城規會編號：TPB/A/YL-SK/435

**提議雨水渠務報告 (Proposed)**

事項：回覆 2026 年 4 月 14 日信函的部門意見

A/YL-SK/435 and A/YL-SK/421 簡介

| Drawing number :                                      | b2-5        |

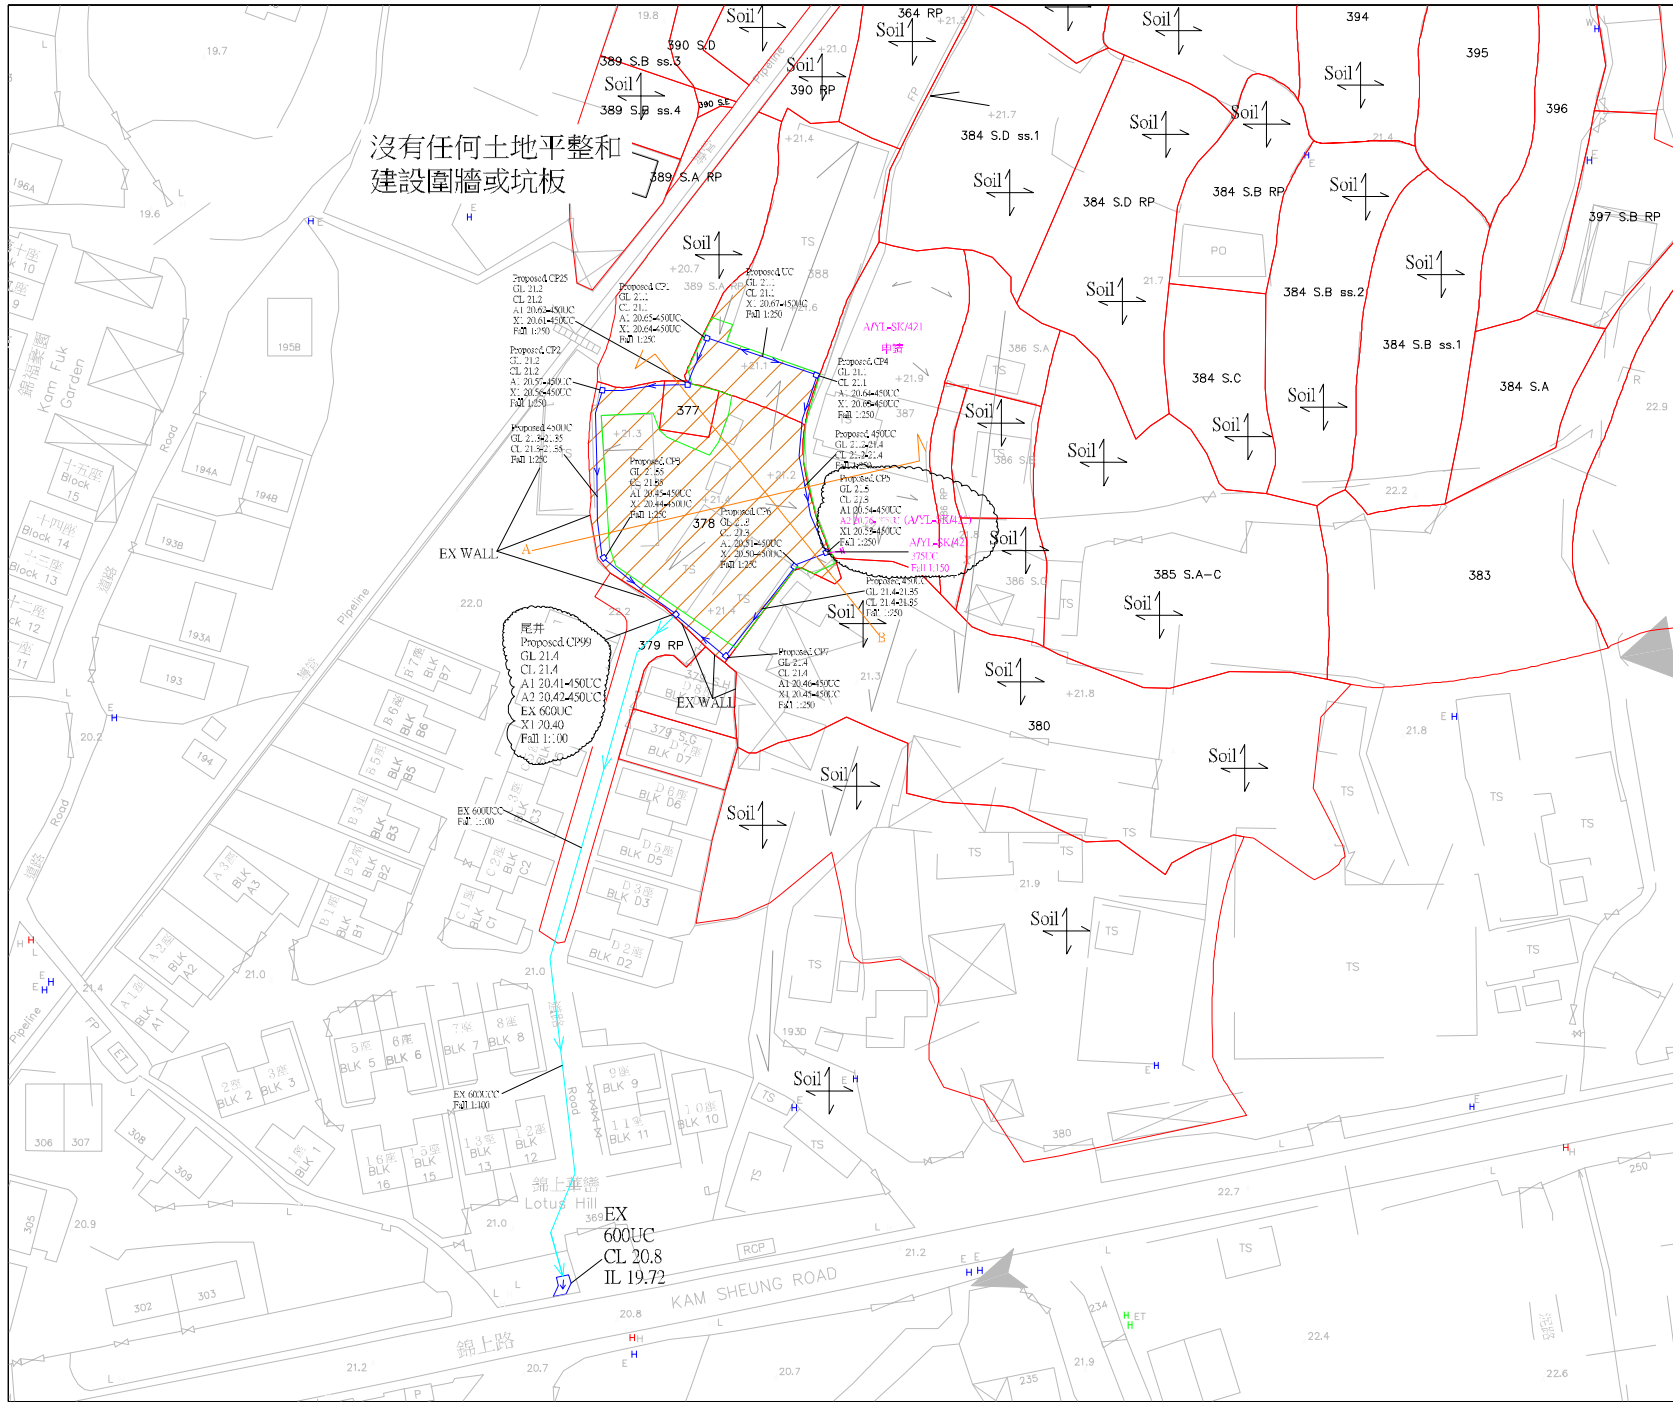
| 2026-04-15 Comments   | 回復   |
|---|--|
| i. Since the proposed drainage system from CP5 to CP99 will collect both the surface runoff from the sites (A/YL-SK/435 and A/YL-SK/421) and the overland flow from adjacent lands. Please further review and upgrade the size and/or the gradient of all drainage facilities accordingly.  | 在b2-5, e1-5, e2-5, e3-5中示  |
| iii. Sand trap or provision alike should be provided before the collected runoff is discharged to the public drainage facilities. Please clearly indicate the above for the proposed last catchpit (CP99) on the drainage plan (Drawing No. b2-3) for clarity.  | 在b2-5, b7-5 中示   |
